to Urban Renewal Agency Board  
cc. Urban Renewal Advisory Committee  
from Nathan Polanski, PE, MIG; Dustin Nilsen, City of Hood River Planning Director  
re The Heights Streetscape Plan – Phase 3 Additional Design Studies  
date April 7, 2023

This memorandum summarizes findings and project team recommendations from the additional design studies requested by the Urban Renewal Agency as part of the Heights Streetscape Phase 3 contract. The additional design studies include:

SUBJECT: Hood River Heights Streetscape Plan –  
13<sup>th</sup> Street/ May Street Intersection Design Refinement

**Figure 1: Roundabout layout for May Street/13<sup>th</sup> Street by American Structurepoint**

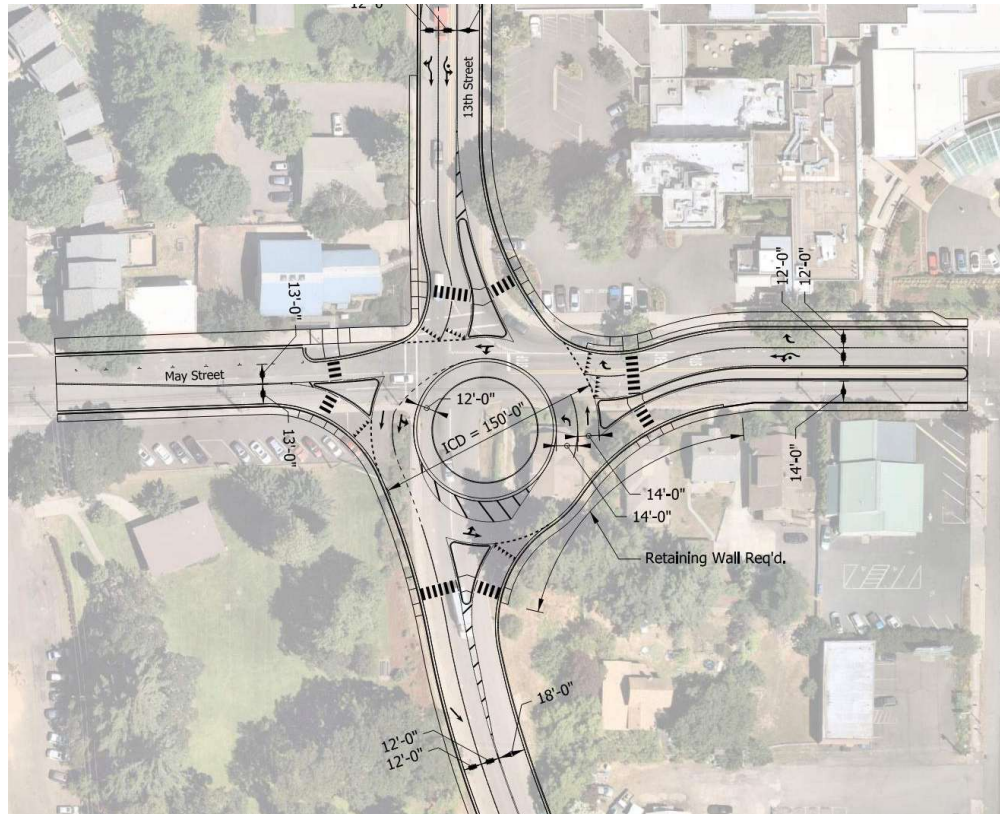
The project team reviewed the roundabout layout (Figure 1) developed by the City's roundabout design consultant to identify potential design refinements and incorporate bicycle facilities into the layout.

Design refinements include:

- the removal of the second circulating lane on the east side of the intersection, which was found to be in excess of the needed intersection capacity,
- modifications to May Street east and west of the roundabout to accommodate a two-way cycle track on the south side of May Street, and
- narrowing travel lanes on 13<sup>th</sup> Street north of the roundabout to accommodate bike lanes as shown in the City's Transportation System Plan (TSP).

**Figure 12: Updated typical 12<sup>th</sup> Street cross section (looking north)**

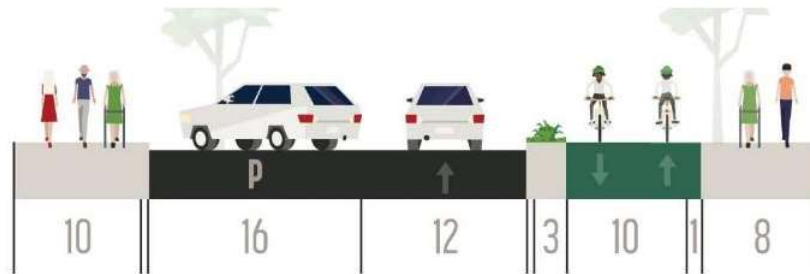
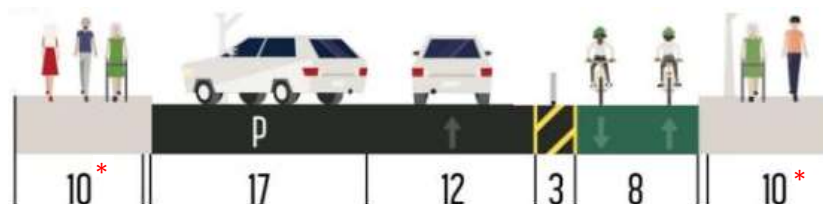
As part of this design review, we explored design standards and design guidance for the size of parking stalls (depth and width), the width of a two-way cycle track, the width and type of separation between cycle track and travel lane and the sidewalk, the anticipated use and level of comfort/access that is provided for each user group, and considerations for emergency access, implementation, and maintenance. Based on our review we have developed an updated typical street cross section (Figure 12) that will continue to be refined as we develop the final preferred concept design.

This cross section increases the depth of the angle parking stall, increases the width of the east sidewalk, decreases the width of the two-way cycle track, and lowers the cycle-track to be at street grade. These refinements are proposed to improve access to parking for people driving, reduce conflicts at intersections for people walking and biking (particularly related to implementing ADA curb ramps at intersections), and to maintain the sidewalk experience for people walking. A key element that is still being explored is the type of delineation to provide separation between the cycle-track and adjacent travel lane; Figure 12 shows a three-foot striped buffer with delineator post. We are continuing to explore how best to provide separation (visual and physical separation if possible) while considering long-term impacts for operations and maintenance of the street throughout the year (e.g., impacts for winter conditions and snow plowing).

**FIGURE 2. 13<sup>TH</sup> STREET/ MAY STREET ROUNDABOUT INTERSECTION CONFIGURATION**

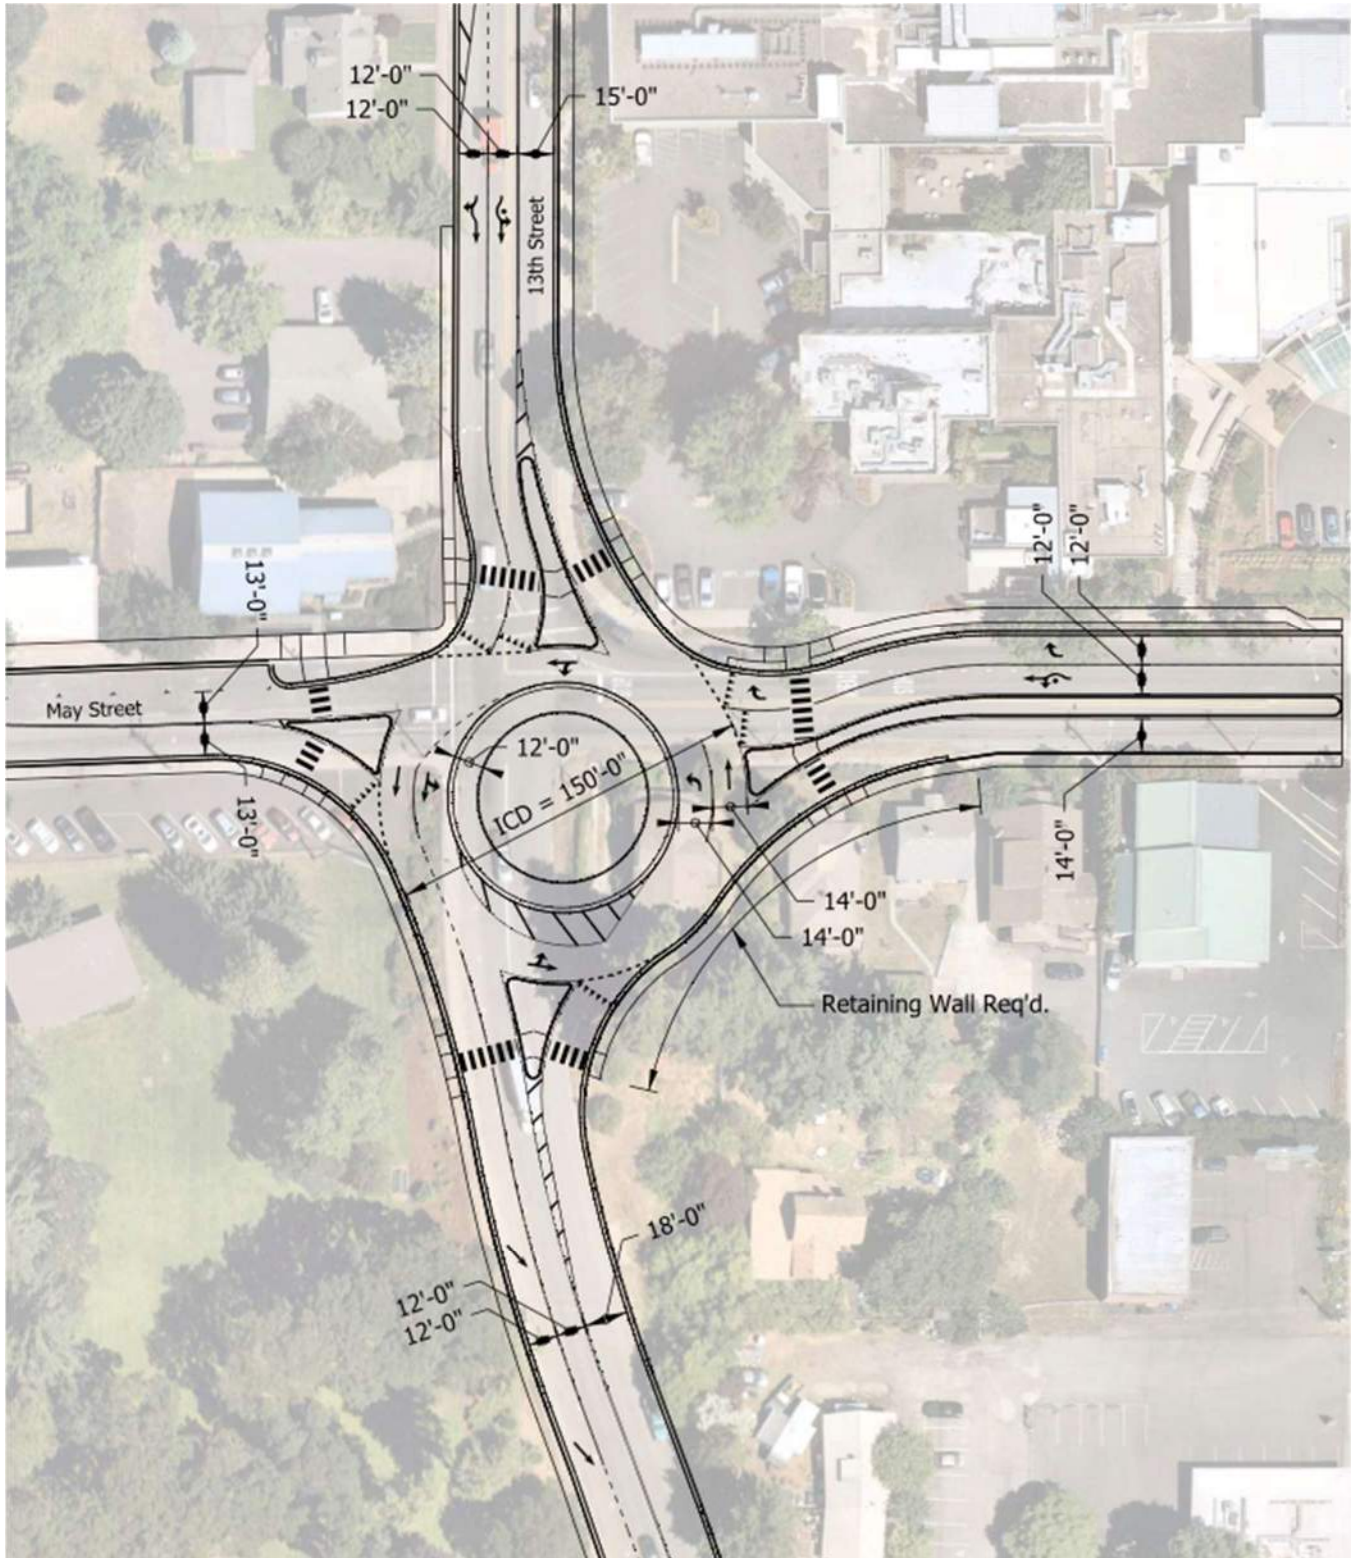
A peer review of the roundabout concept was conducted that yielded the following comments and potential design refinements.

1. There should not be a need for two circulating lanes in the roundabout on the east side (from the northbound entrance to the northbound exit).
2. The westbound through/left entry lane alignment looks off and would guide entering traffic into the island rather than the circulating roadway.

3. The westbound right turn lane should not enter the roundabout circulating roadway.
4. The drawing does not include the desired bicycle facilities and only includes narrow sidewalks on most approaches. In particular, if a two-way cycle track is desired on the south leg, an enhanced crossing should be considered. One option could be a protected intersection design, similar to the roundabout at 9<sup>th</sup> Street/Wilson Avenue in Bend, Oregon<sup>3</sup>.

5. Two-lane entries and exits may need supplemental pedestrian actuated flashing beacons and warning signs for safety (impacts cost but not footprint).

6. Truck turning templates and fastest path analysis should be completed for all approaches.
